DETAILED COMMENTS FOR THE WYOMING DRAFT ENVIRONMENTAL IMPACT STATEMENT FOR THE POWDER RIVER BASIN OIL AND GAS PROJECT

I. DRAFT EIS SURFACE WATER COMMENTS

Figure J
Powder River at Moorhead
Stream Flow and EC - Fitted Distributions

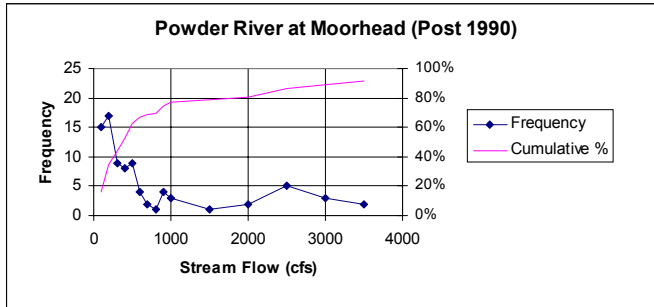
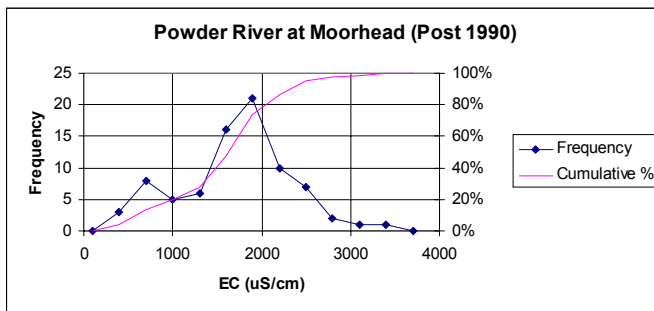
EPA performed an impact analysis for the Powder River in which flow and water quality parameter distributions are considered, known as a Monte Carlo probabilistic analysis. Figure J, page 16, shows the distribution of post-1990 stream flow and EC data for the Powder River at Moorhead used as input in this analysis. Figure K, page 16, shows the distribution of CBM EC and maximum produced water discharge for the Middle Powder River. The EC distribution and the five-year average discharge rates (calculated as described in the section on CBM discharge) corresponding to the maximum CBM water discharge were used as input in this analysis. Figure L, page 17, shows that the frequency of flows with EC below 1300 uS/cm (the no reduction threshold for alfalfa production) may decrease from approximately 30% to approximately 20%. At the same time, there is likely to be an increase in the volume of flow, as shown in Figure M, page 17, due to mixing CBM discharge with river flows.

Figure N Limits on CBM Discharge and Number of Wells

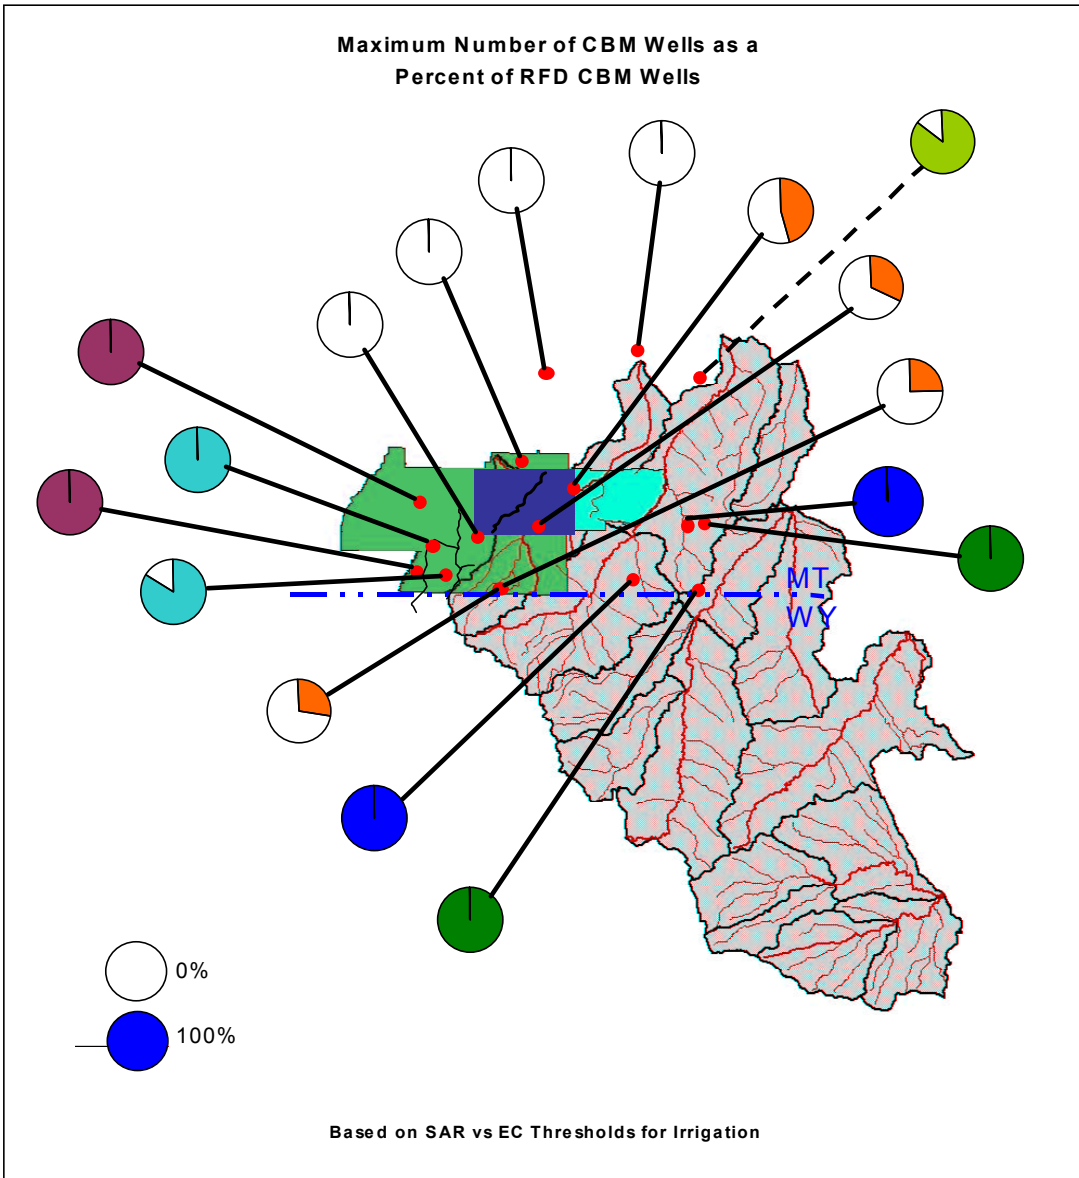
EPA's impact analyses also includes a calculation to determine limits on CBM discharge to ensure that the receiving streams meet the irrigation water quality criteria defined in terms of the EC-SAR relationship as well as any crop-related limits on salinity. Discharge limits based on irrigation season low monthly stream flows are shown in Table C and Figure N, pages 11 and 18. Discharge limits based on 7Q10 flows are shown in Table D and Figure O, pages 11 and 19. Under either flow assumption, discharge to the Tongue River would need to be limited to a small fraction of the discharge projected in the RFD of CBM development. Discharge to the Little Powder would not need to be limited under either flow assumption. Discharge to the Powder River would not need to be limited under the irrigation season low monthly flow assumption, but

Figure O
Limits on CBM Discharge and Number of Wells
Based on EPA Impact Analysis with 7Q10 Flows

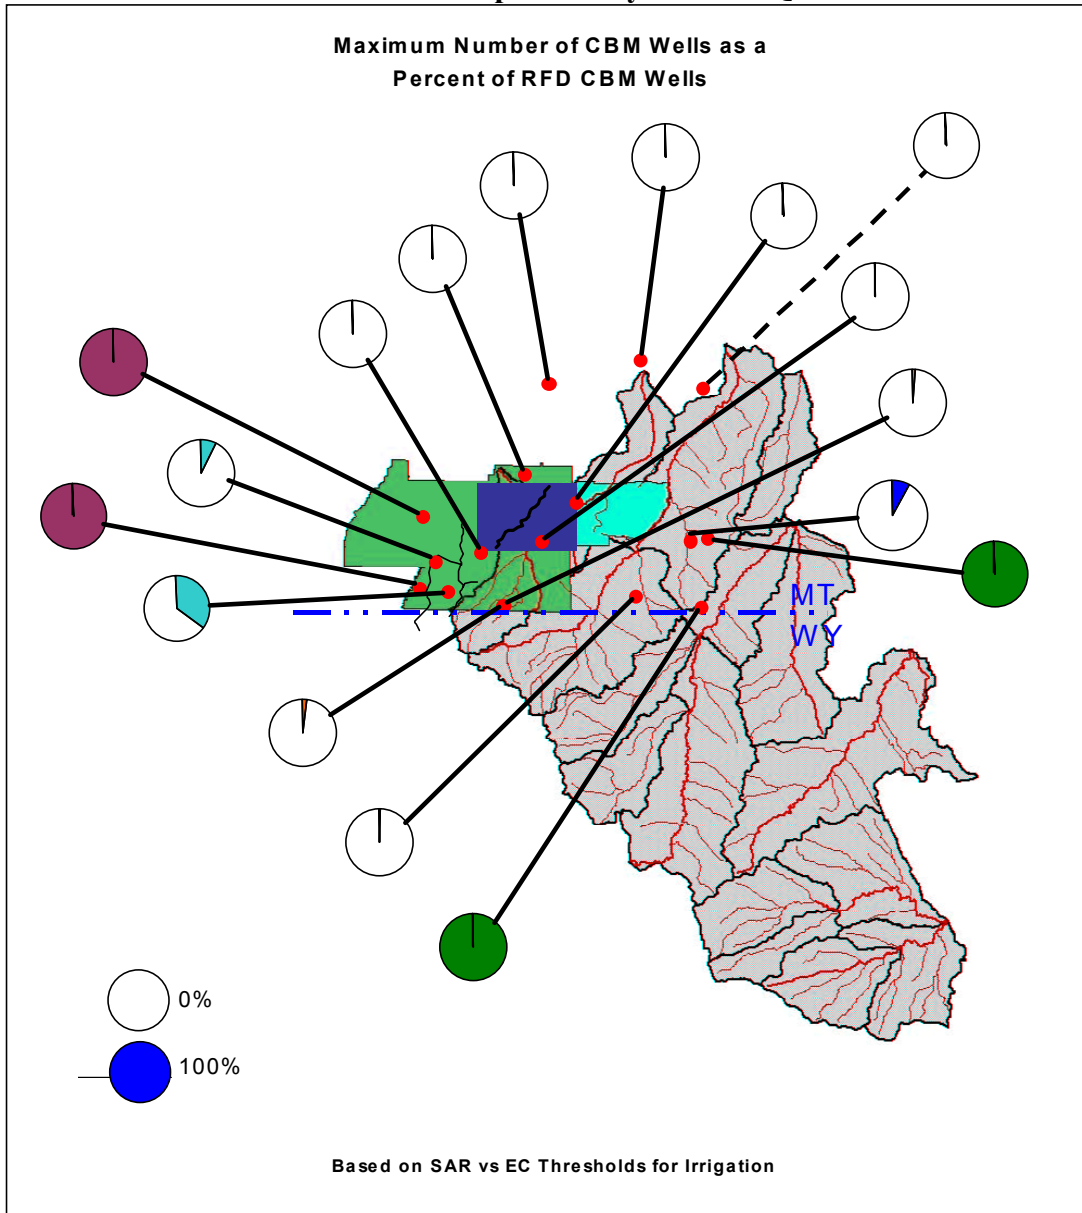
would need to be limited to a small fraction under the 7Q10 assumption.

Figure 1. Assessing the maintenance leaching fraction under conventional irrigation methods.

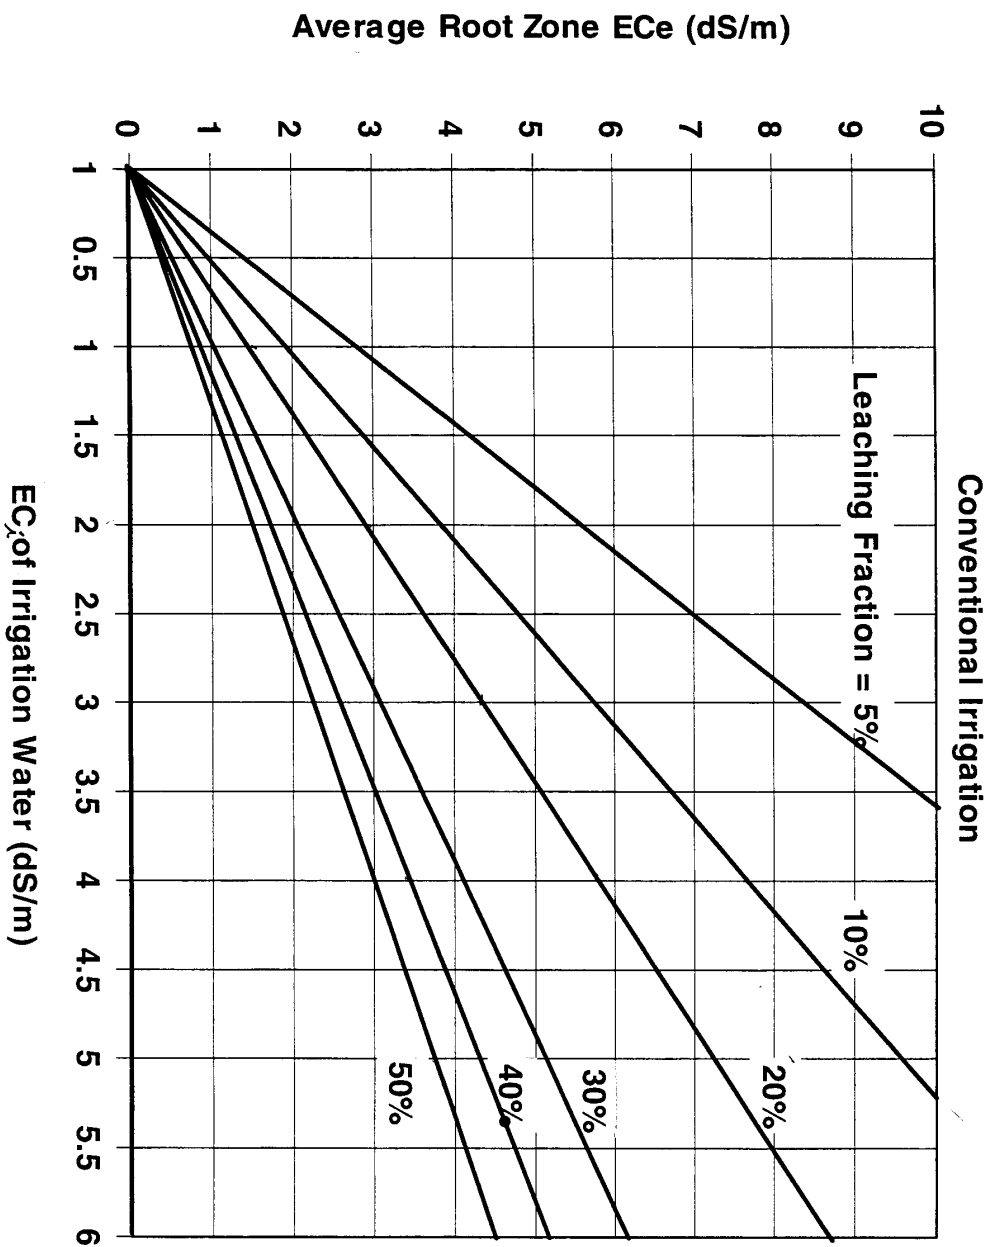
For alfalfa irrigated with an EC_w near 1,300 dS/cm (1.3 dS/m) then the leaching fraction must be 15 to 20 percent. In other words, if the crop needs 24 inches of water per season then 24 inches plus 20 percent (4.8) or a total of 28.8 inches of water must be applied in order to maintain maximum yield. If the irrigation water salinity is greater than 1,300 μ S/cm or the leaching fraction is less than 20 percent, yields will be decreased. There would be a 10 percent yield decrease if the average irrigation water conductivity were 2,200 μ S/cm (2.2 dS/m) and a 25 percent yield decrease if the average irrigation water conductivity is 3,600 dS/cm (3.6 dS/m). In order to determine the effects of changing the leaching fraction, an extra step is required.

Figure 1, from Hansen (page 29 and shown on the next page), gives the relationship between the EC of the irrigation water, indicated as the EC in the root zone, and the EC of the soil water at various leaching fractions. Note that an irrigation water EC of 1.3 dS/m and a leaching fraction of 20% results in an "average root zone" EC of 2 dS/m. The "average root zone" EC is the same as the salinity of the soil water. Figure 1 indicates that if the EC of the irrigation is 1.3 dS/m and the leaching fraction is 5%, the resulting soil water salinity will be about 3.6 dS/m. According to Table 4, this corresponds to about a 25% reduction in yield. If the leaching fraction is 40%, then the irrigation water EC could be as high as 2 dS/m without causing decreases in yield.

Figure 3. Assessing the effect of salinity and sodium adsorption ratio on infiltration rate.

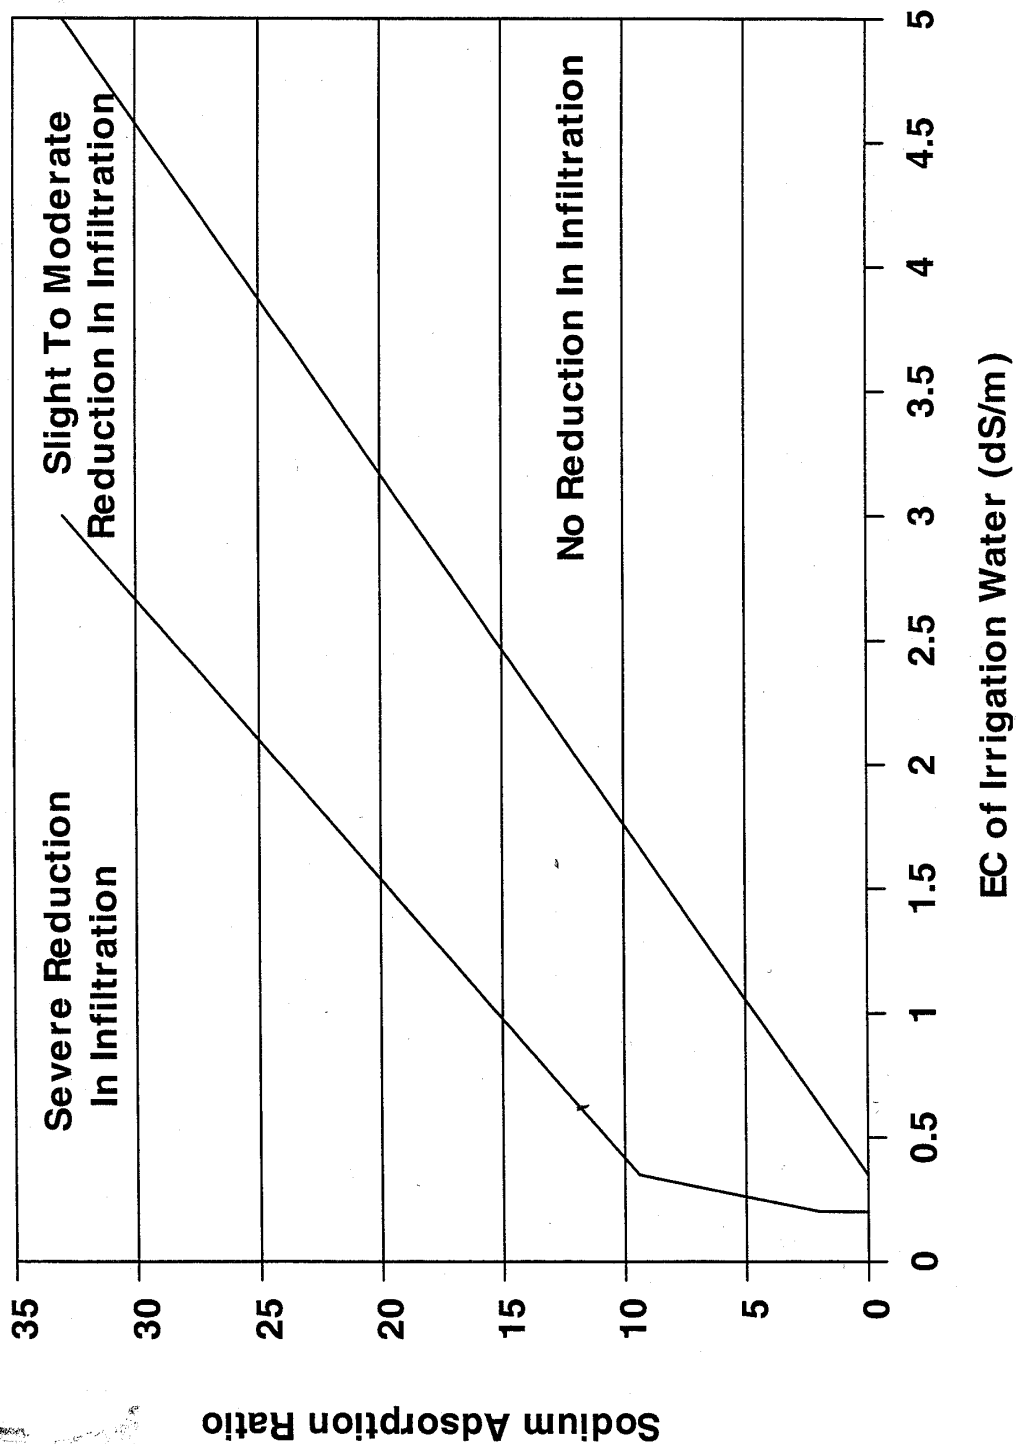
Restriction on Use: The "Restriction on Use" shown in Figure 3 (adapted from Hansen, page 32) is divided into three degrees of severity: none, slight to moderate, and severe. The divisions are somewhat arbitrary since change occurs gradually and there is no clearcut breaking point. A change of 10 to 20 percent above or below a guideline value has little significance if considered in proper perspective with other factors affecting yield. Field studies, research trials and

Table 1 shows how SAR and EC levels restrict infiltration. For instance, if the SAR ranges from 0 - 3 and the EC is less than 0.2 dS/m (i.e. less than 200 $\mu\text{S}/\text{cm}$) there will be severe reductions in infiltration. If the EC is between 0.2 and 0.7 dS/m, there will be slight to moderate reductions in infiltration. If the EC is greater than 0.7 dS/m, there will be no reductions in infiltration. Figure 3 (from Hansen et. al.) gives these relationships in a graphical format. It is possible to derive the mathematical relationships of the lines in this figure and the resulting formula can be used to calculate the SAR values that would result in reductions in infiltration at any EC. The mathematical relationship between EC and the SAR that will result in no reduction in infiltration is: $\text{SAR} = (\text{EC} \times 0.0071) - 2.4754$ where EC is expressed as $\mu\text{S}/\text{cm}$.
